Project	IEEE 802.16 Broadband Wireless Access Working Group < http://ieee802.org/16 >	
Title	Resource retaining time and Call recovery scheme during HO — HO Ad-Hoc Consensus Contribution	
Date	[2004-07-07]	
Submitted		
Source(s)	Hyunjeong Kang, Jungje Son, Changhoi Koo Samsung Electronics	Voice: +82-31-279-5091 Fax:+82-31-279-5130 { hyunjeong.kang , jungje.son , chkoo }@samsung.com
	Phillip Barber, Broadband Mobile Tech.	pbarber@BroadbandMobileTech.com
	Jaesun Cha, Sungcheol Chang, ETRI	
	Yong-Ho Kim, Kihyoung Cho, Changjae Lee LG Electronics, Inc.	{ ronnykim , kihyoung , cjlee16 }@lge.com
	Seong-Choon Lee, Min-Sung Kim, KT	{ lsc , cyberk }@kt.co.kr
Re:	This contribution is for call for contribution IEEEE802.16e/D3-2004	
Abstract	This contribution proposes the resource retaining time and call recovery scheme during HO. It is a result of harmonization with consensus in HO Ad Hoc of IEEE802.16e.	
Purpose	Propose the enhanced call recovery scheme during HO

Resource retaining time and Call recovery scheme during HO

II. Proposed Text Changes

Figure E.X1 – Example HO process with MSS’s Resource Retain by MSS request

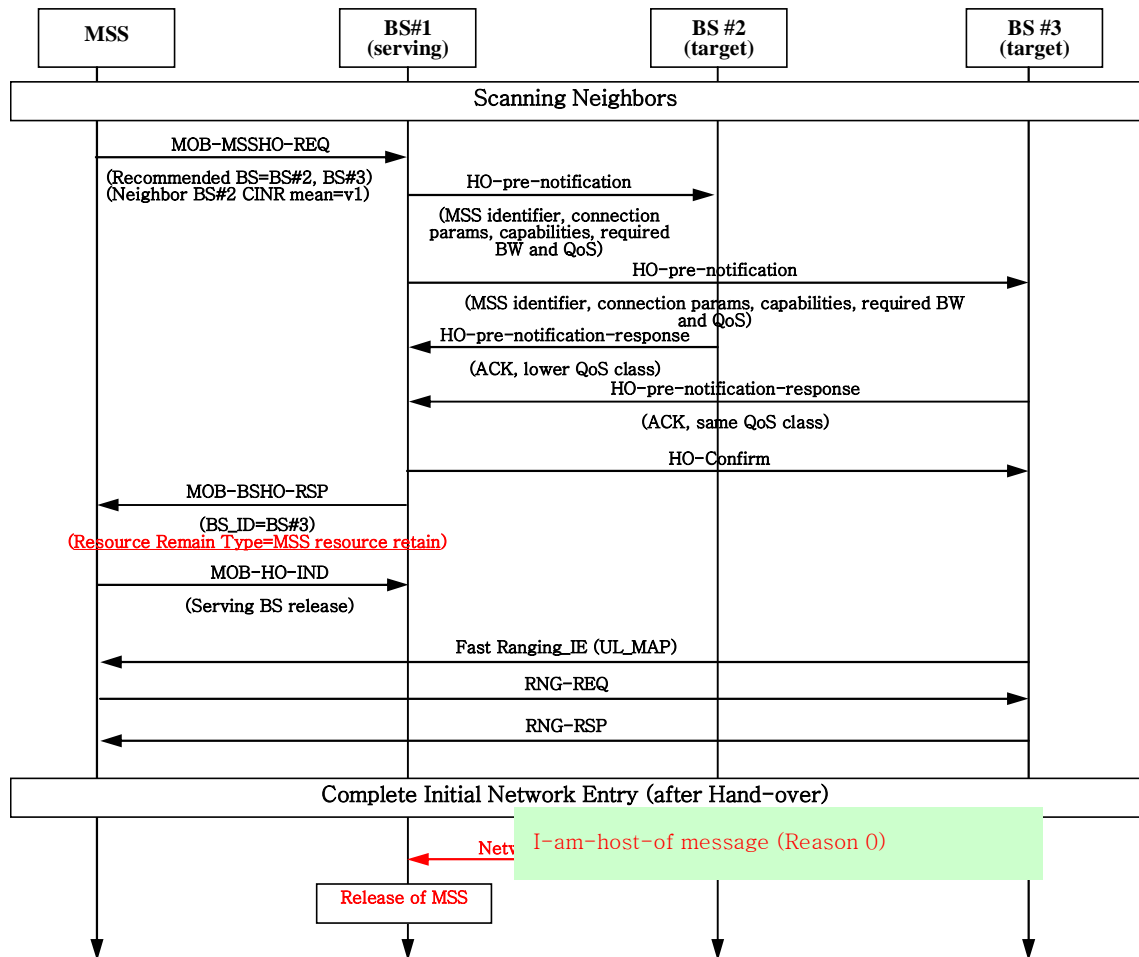
We propose the following remedies in IEEE P802.16e/D3 to provide the handover enhancement method related with the resource retain timer and call recovery mechanism

If the Serving BS determines to retain the connection information of an MSS which has sent MOB-HO-IND with HO_IND_type=00 and begun the actual HO, this connection information may be used by the MSS in order to perform an expedited re-entry operation with Target BS or the Serving BS.

The Serving BS shall notify the MSS of retention of MSS connection information through Resource Remain Type in MOB-BSHO-RSP message or MOB-BSHO-REQ message during handover request/response handshake operation. If Resource Remain Type=1 and Resource Retain Time is not included as a TLV item in the message, then the Serving BS and MSS shall use the System Resource Retain Time timer.

| [Figure E.X3 – Example HO process after drop](#)

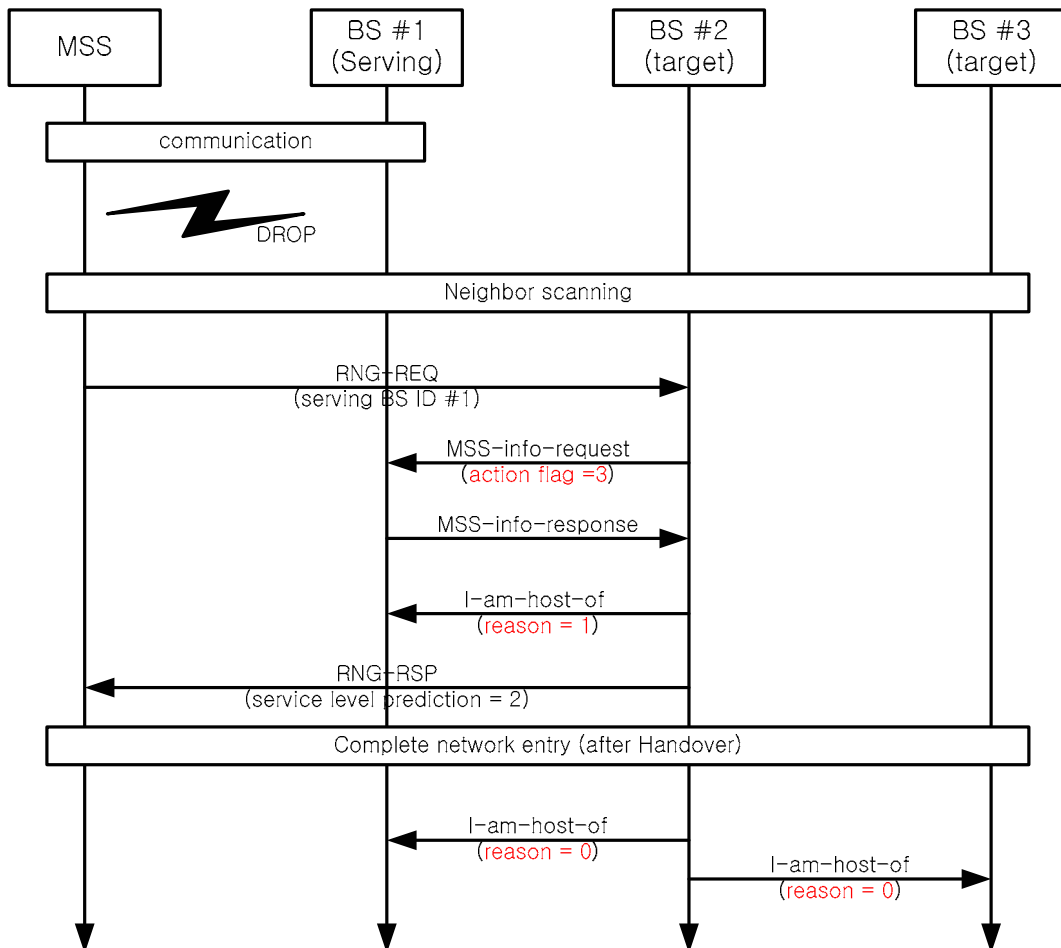
When the MSS has detected a drop, it shall resume communication with the Serving BS by sending MOB-HO-IND message with HO_IND type = 01 (HO cancel). If resuming communication fails with the Serving BS then the MSS shall attempt network re-entry with its preferred Target BS as outlined in Section 6.3.20.4. When the Serving BS has detected a drop, it shall react as if a MOB-HO-IND MAC Management message has been received with HO_IND_type indicating Serving BS release.

When the Target BS has detected a failed HO entry/re-entry attempt, it may inform the Serving BS of HO failure through a backbone message indicating Handover Failure.
